Safety Notice

SN-663

Models Affected: XTPro56 & XTPro 60 Aerials

SUBJECT: Single Stick Control Adjustment

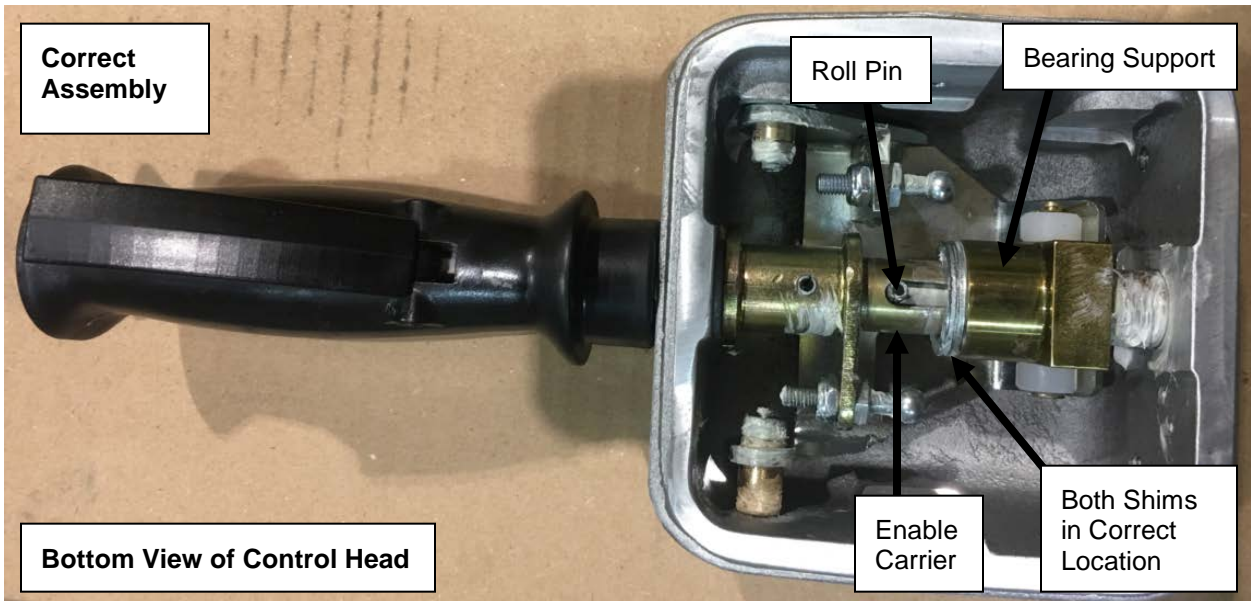
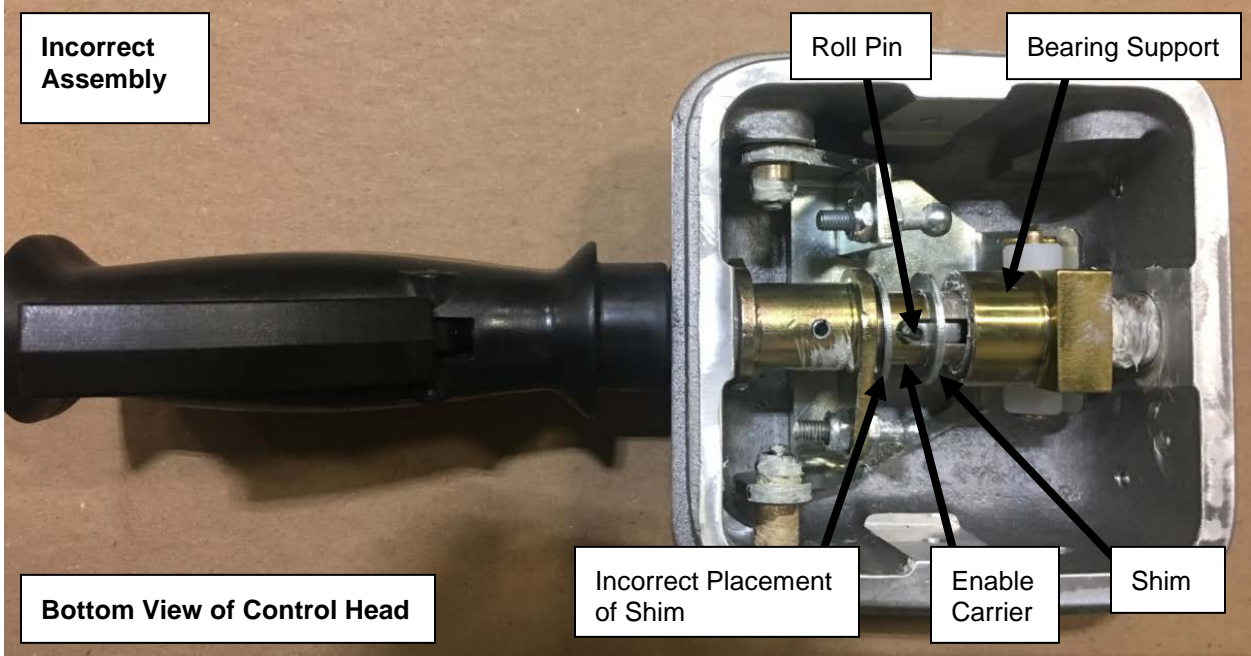
Some XTPro units may have upper control single stick enable trigger adjusted or assembled incorrectly. If the enable trigger is not adjusted correctly, the boom could function without depressing the enable trigger. **Inadvertent boom movement may occur if the single stick is operated without depressing the enable trigger.**

- a. Remove the plastic cap and lower the boot over the single stick mechanism.
 - b. Inspect the position of the two shims on the enable carrier.
 - c. If only one shim is between the roll pin and bearing support, the single stick is assembled incorrectly. Contact your local TEREX dealer to arrange repair. The control head must be assembled properly to provide allowance for wear to attain rated boom speeds.

- d. If both shims are between the roll pin and bearing support, the single stick is assembled properly. No further action is required for this bulletin. Continue to perform regular inspections and maintenance as stated in the manuals.

Proper adjustment of the single stick control is described in the manual. Terex will provide field service kit Z1496 for units that have the enable trigger adjusted or assembled incorrectly at no cost to the owner.
